MEMO

To: Kristopher Byrd, Well Construction and Compliance Section Manager
From: Travis Kelly, Well Construction Compliance Coordinator
Subject: Review of Water Right Application G-19203
Date: February 1, 2022

Groundwater Application Review Summary Form

Application # G- 19203

Figure 2. Well Location Map

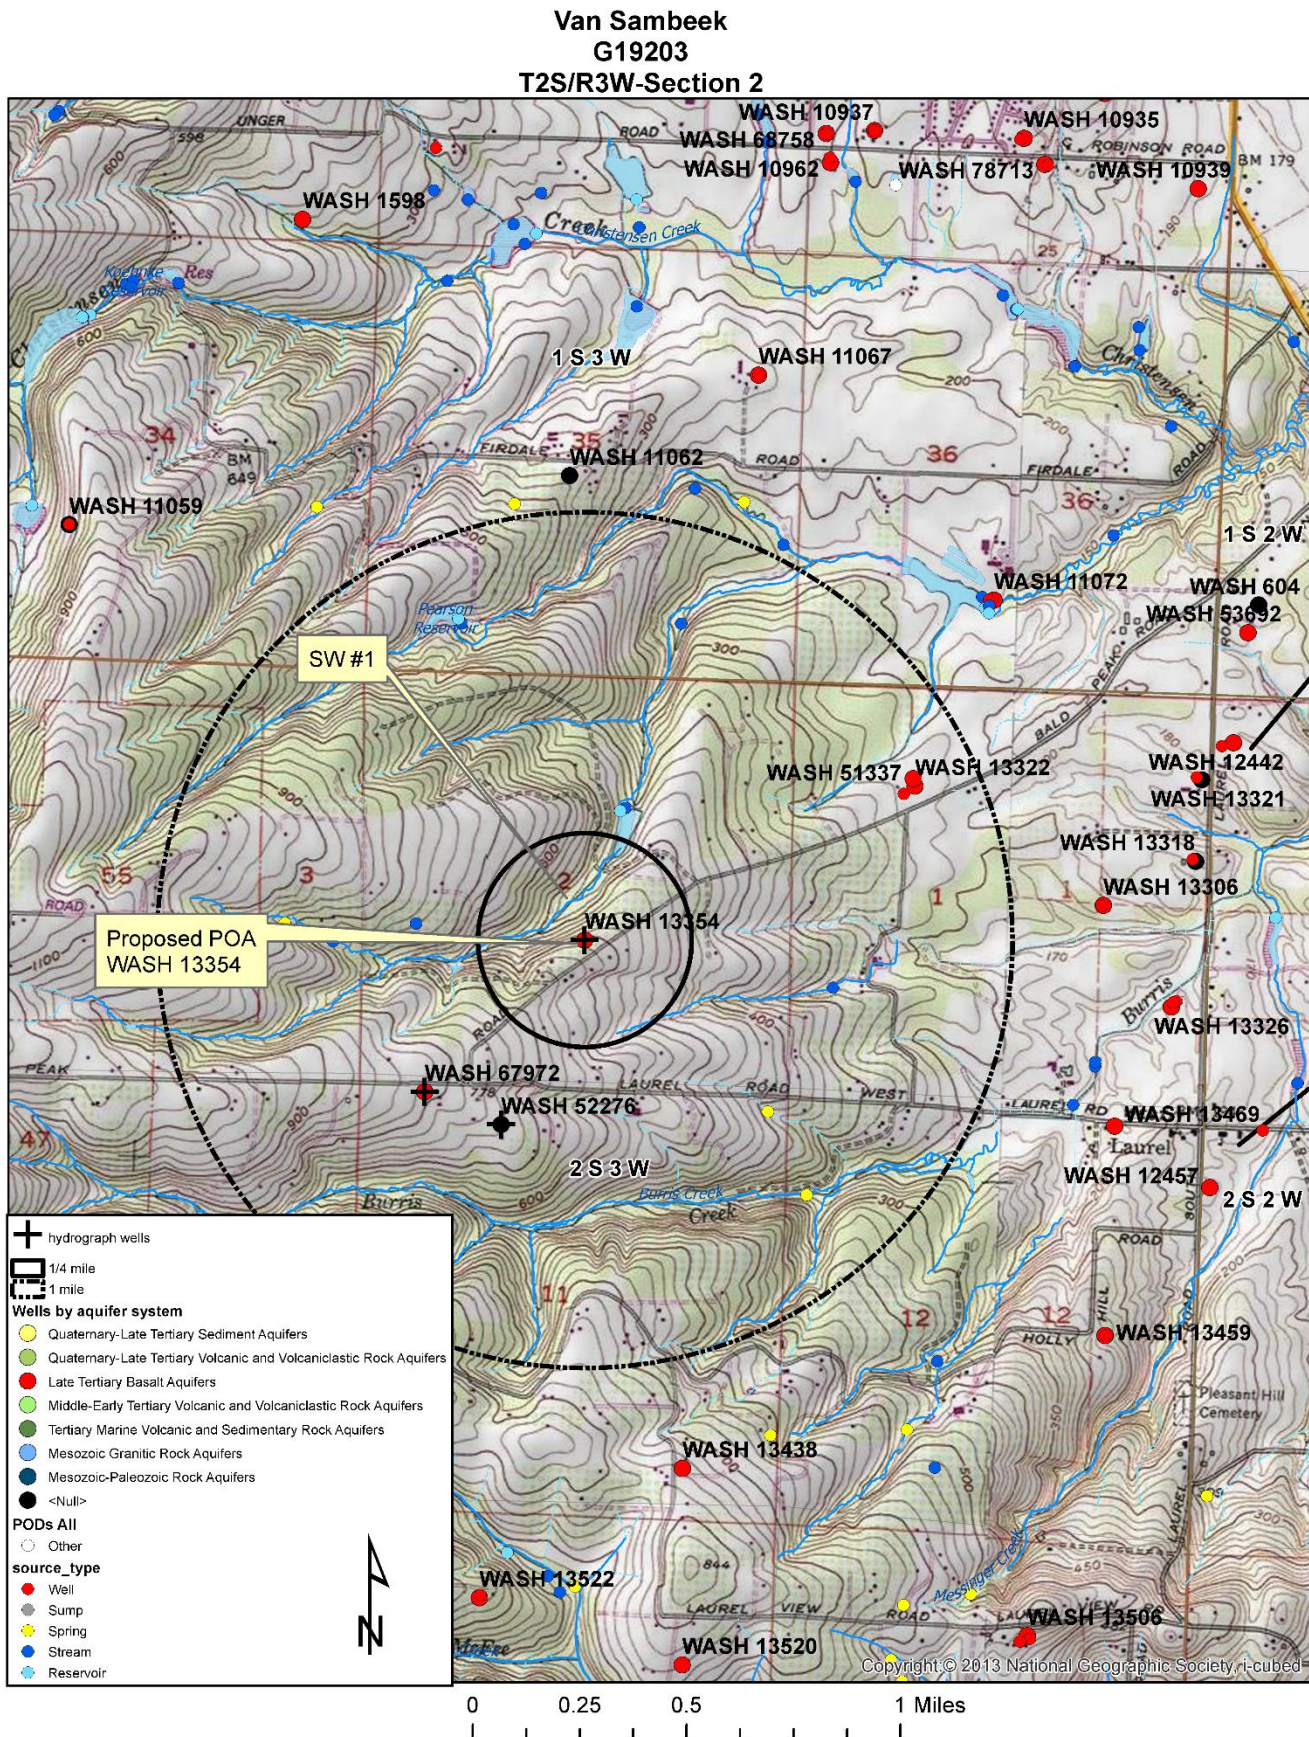
A4. **Comments:** *no metes and bounds provided in the application. This location is estimated after plotting the well in ArcGIS.

Figure 3. Water-Level Measurements in Nearby Wells. WASH 13354 measurement in 2014 was reported without a month or day.

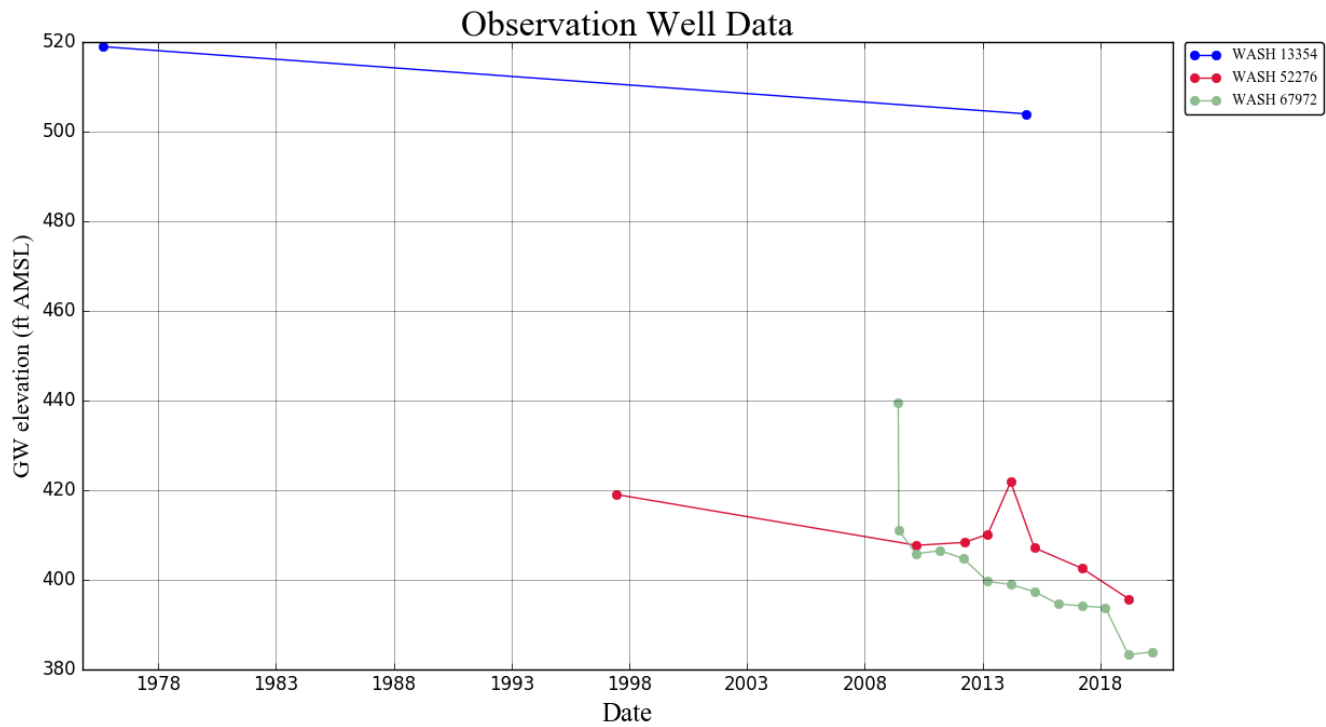
The subject well is located within a basalt aquifer affected by the Chehalem Groundwater Limited Area rules. Wells in this groundwater administrative area are sensitive to overdraft. Nearby water level data indicate a downward trend; WASH 52276 and WASH 67972 show a decline exceeding 15 feet over the period of record. The subject well has two available reported water level measurements showing 15 feet of decline, but the second one is reported within a year without providing a month or day which makes it difficult to determine if this is a seasonal fluctuation or a long-term trend. However, the subject well has an open interval that is coincident with that at WASH 52276, which shows a decline that would trigger the standard 15 foot Willamette Basin Basalt decline limit. This indicates the aquifer does not have the capacity to support the current level of use without water level decline. Therefore new uses are not within the capacity of the resource.

Figure 4. Cross Sectional Diagram

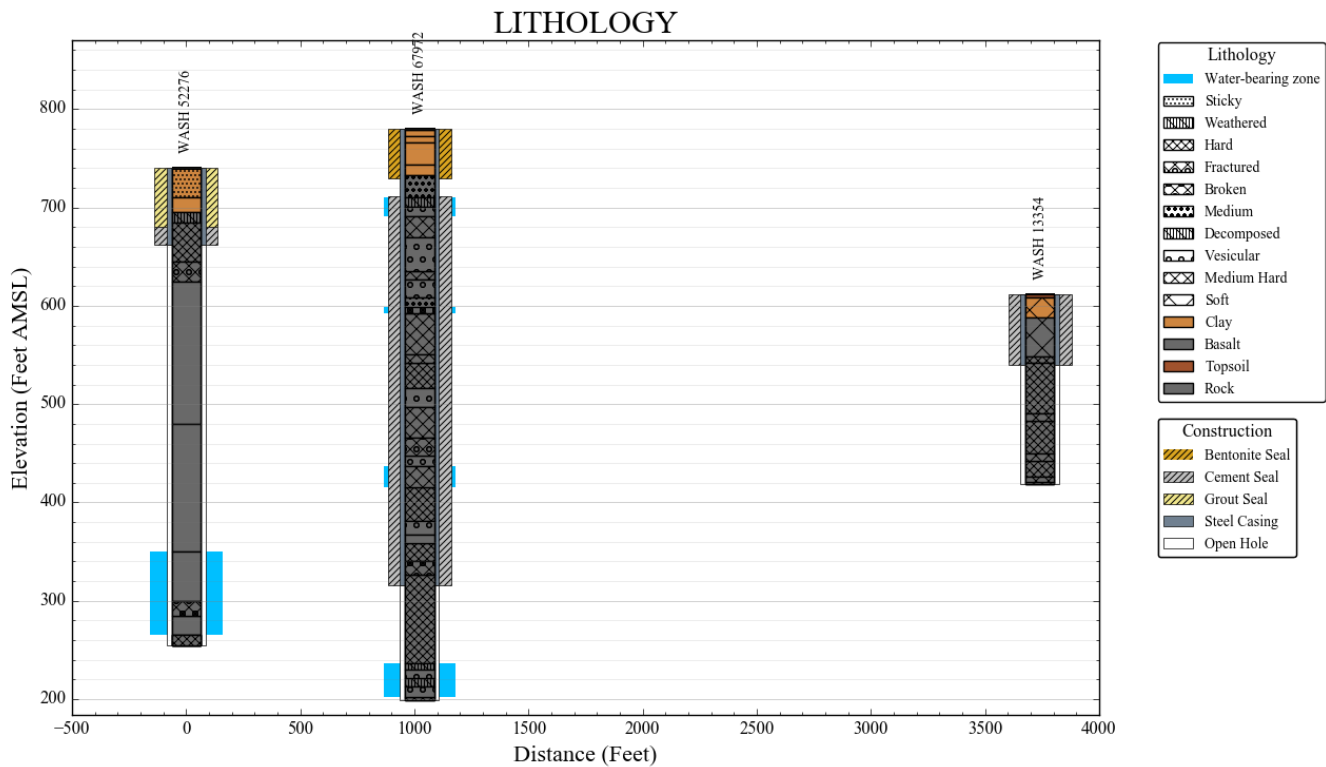
Basis for aquifer hydraulic connection evaluation: Water-bearing zones are reported in the confined interflow zones of the CRBG. The open interval in the subject well is coincident with or above perennial reaches of nearby creeks. The creeks have incised through several hundred feet of CRBG. Groundwater from the uplands likely discharges to surface water, providing baseflow or spring flow to sustain nearby perennial reaches of the creek.
